Permit Number: 070043

**City of Portland, Maine - Building or Use Permit Application**

Proposed Project Description: Remove interior wall & replace w/ LVL beam, build out new bathroom	Signature:	Signature: <i>Chapman 1/7/07</i>
PEDESTRIAN ACTIVITIES DISTRICT (P.A.D.)		
Action: <input type="checkbox"/> Approved <input type="checkbox"/> Approved w/Conditions <input type="checkbox"/> Denied		
Signature:		Date:

**Dept:** Zoning      **Status:** Approved with Conditions      **Reviewer:** Ann Machado      **Approval Date:** 01/11/2007  
**Note:** **Ok to Issue:**

# AFTER

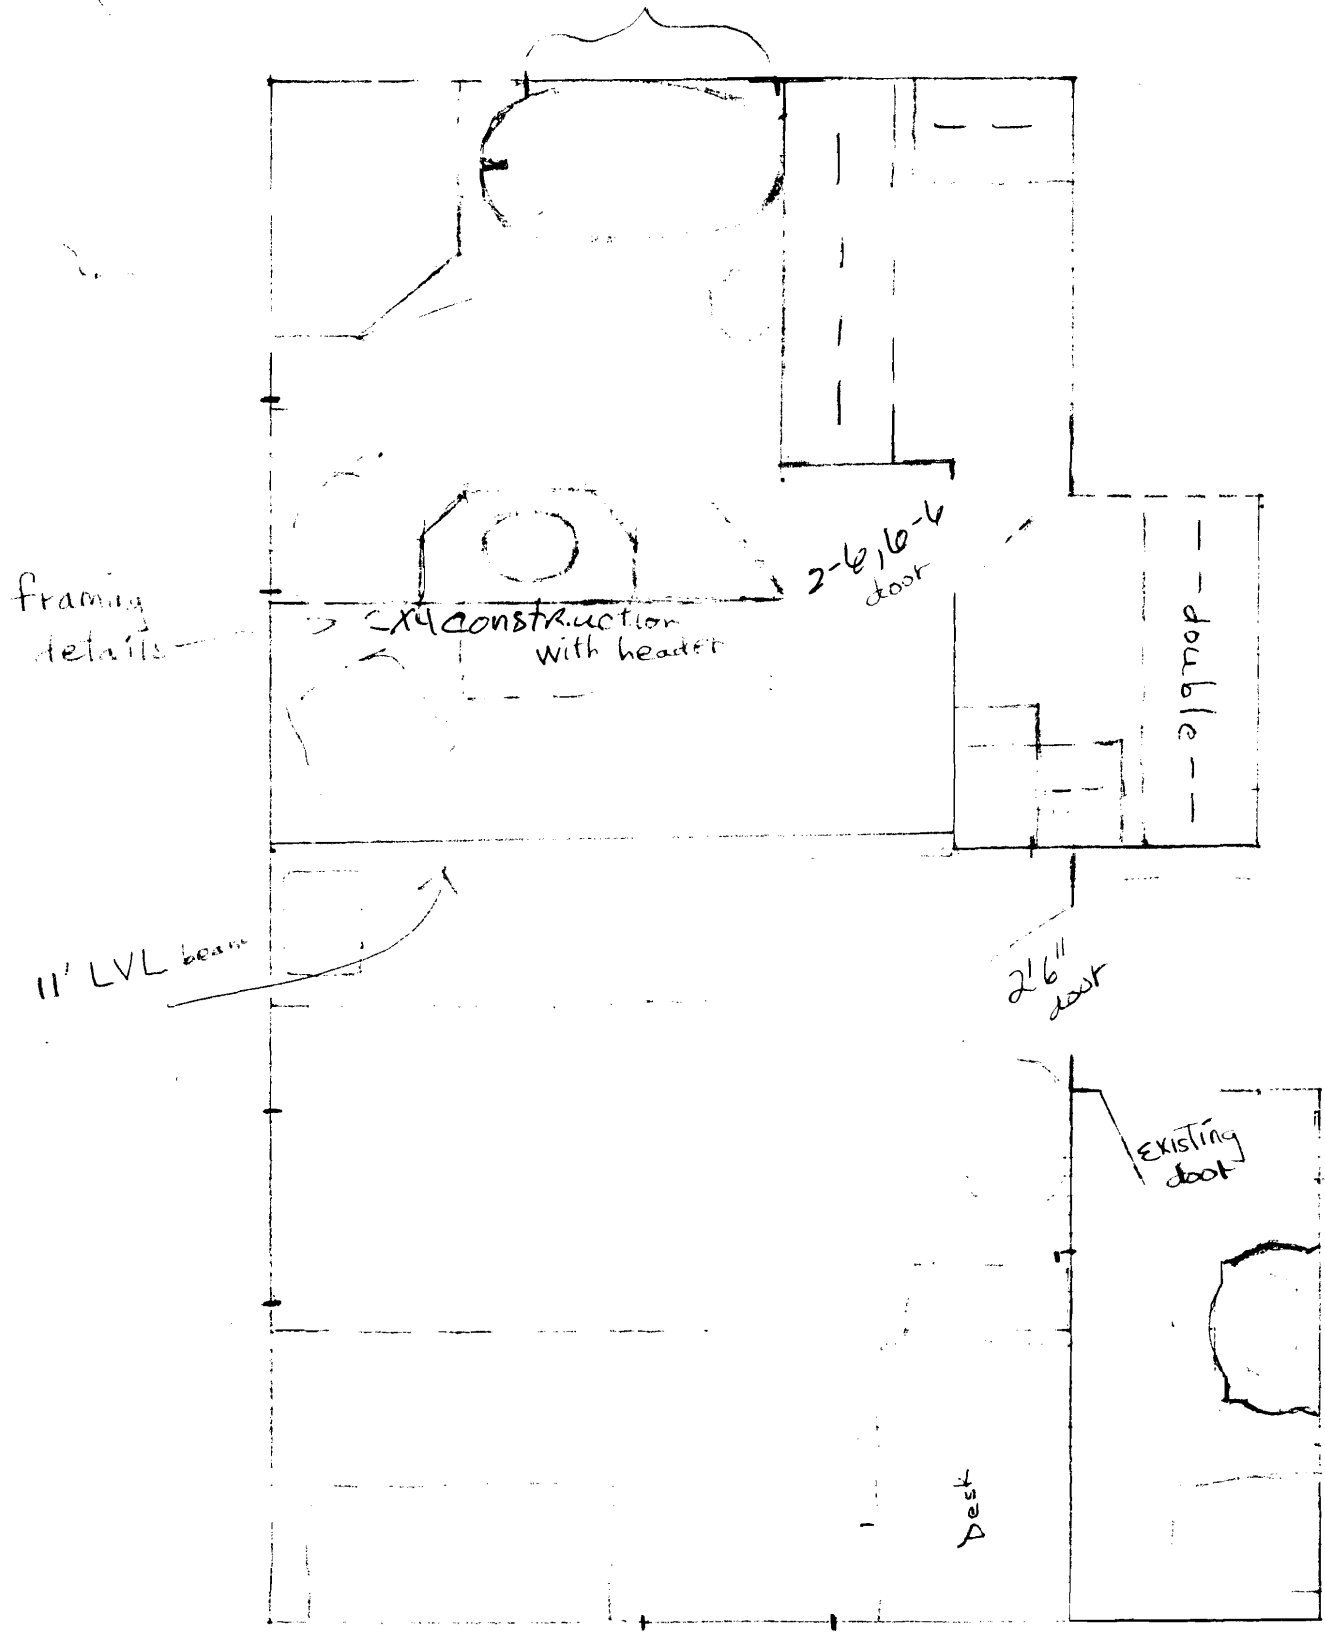
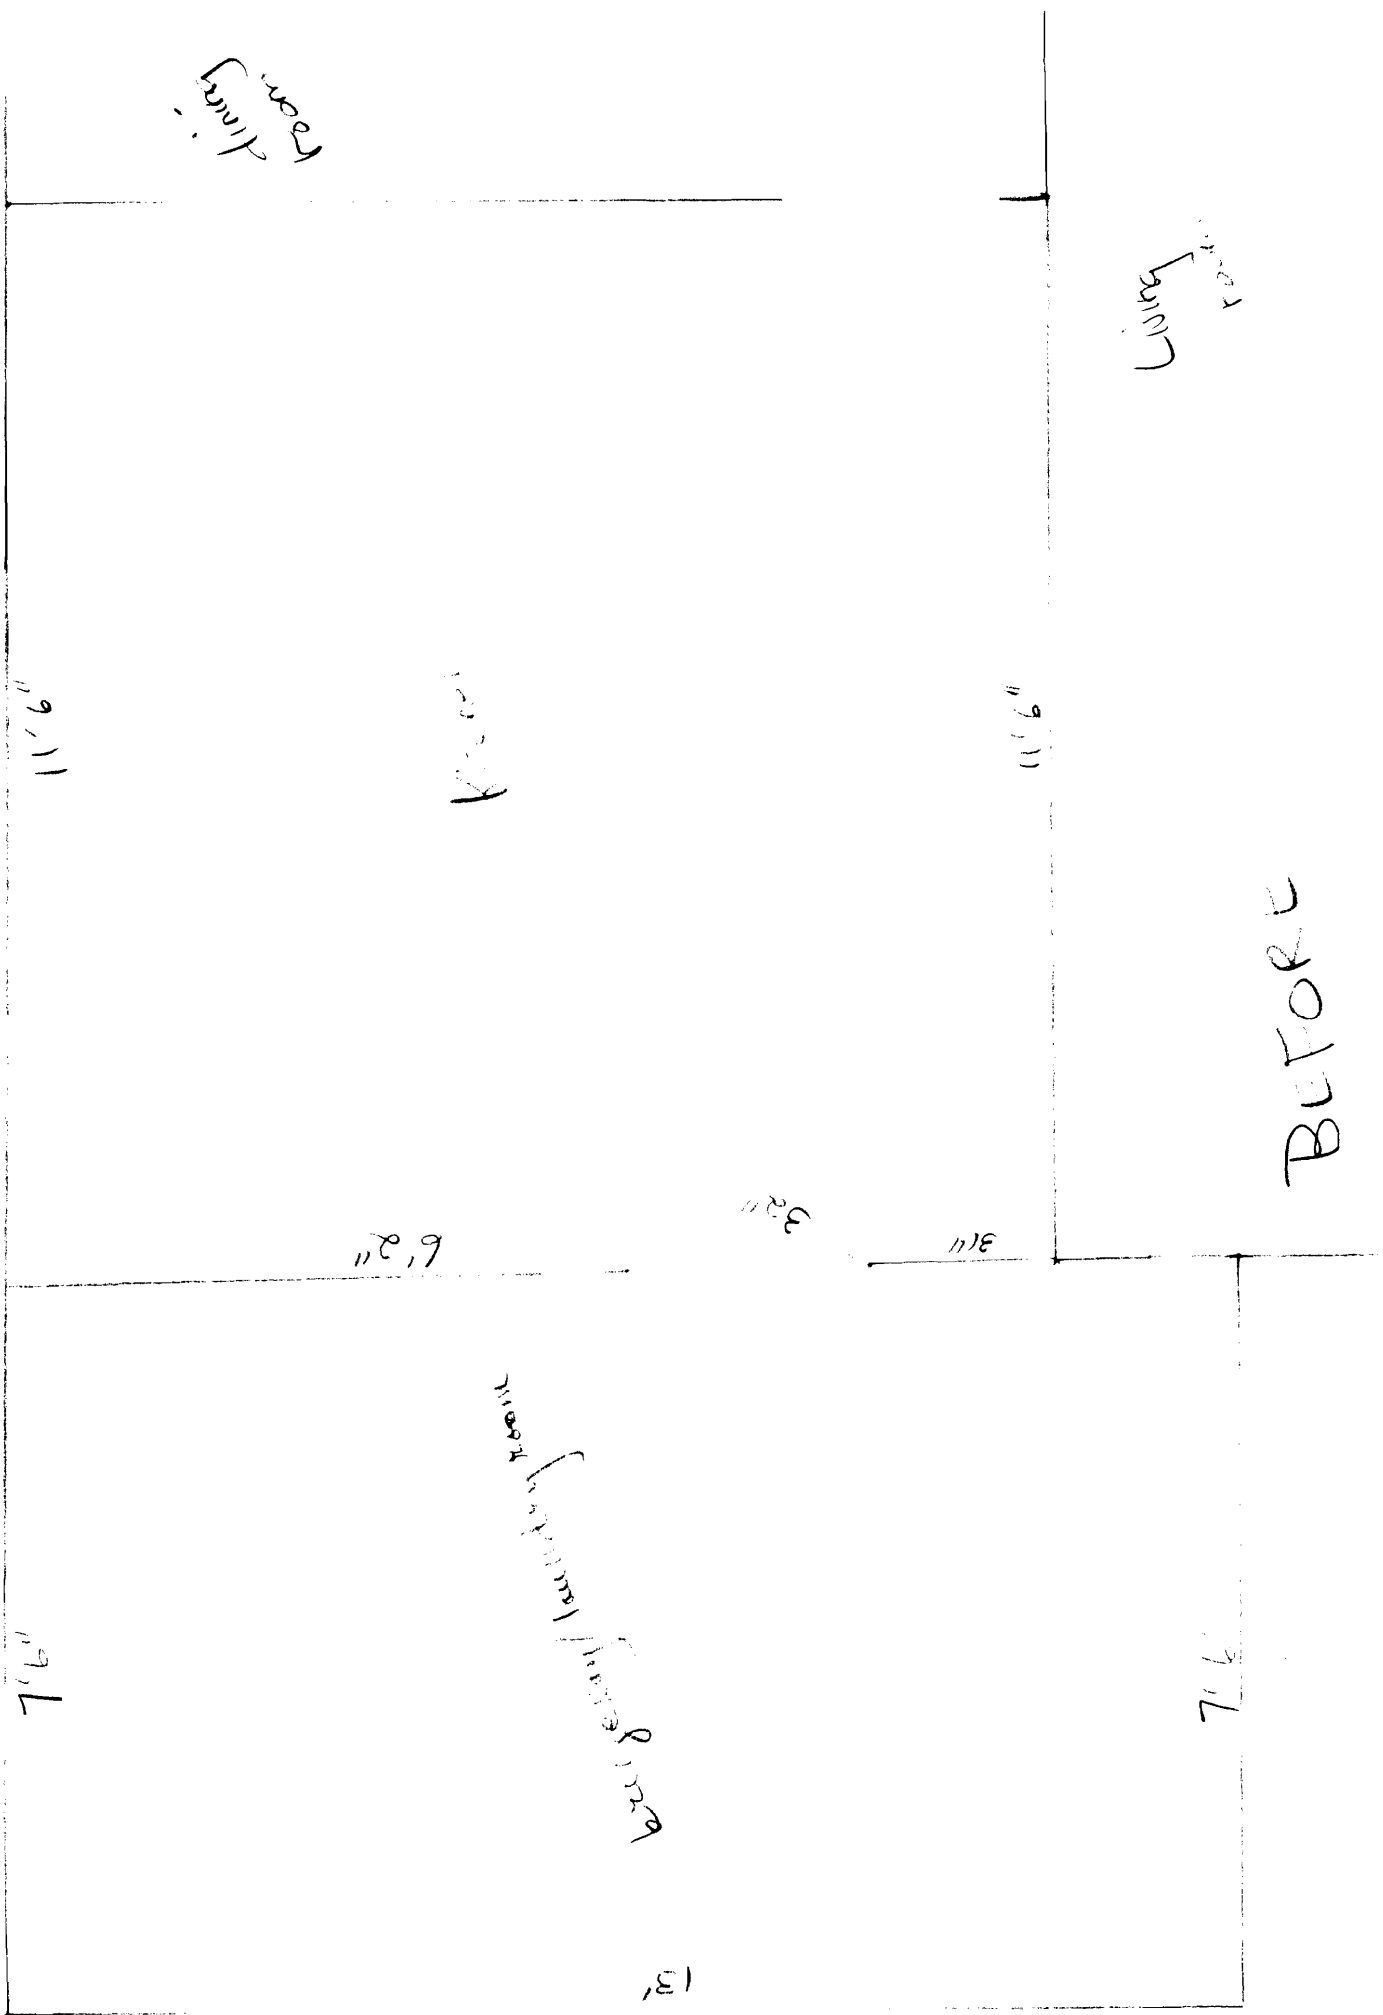
- 1) Separate permits are required for any electrical, plumbing, or HVAC systems. Separate plans may need to be submitted for approval as a part of this process.
- 2) The design load spec sheets for any engineered beam(s) must be submitted to this office.
- 3) Application approval based upon information provided by applicant. Any deviation from approved plans requires separate review and approval prior to work.
- 4) Permit approved based on the plans submitted and reviewed w/owner/contractor, with additional information as agreed on and as noted on plans.
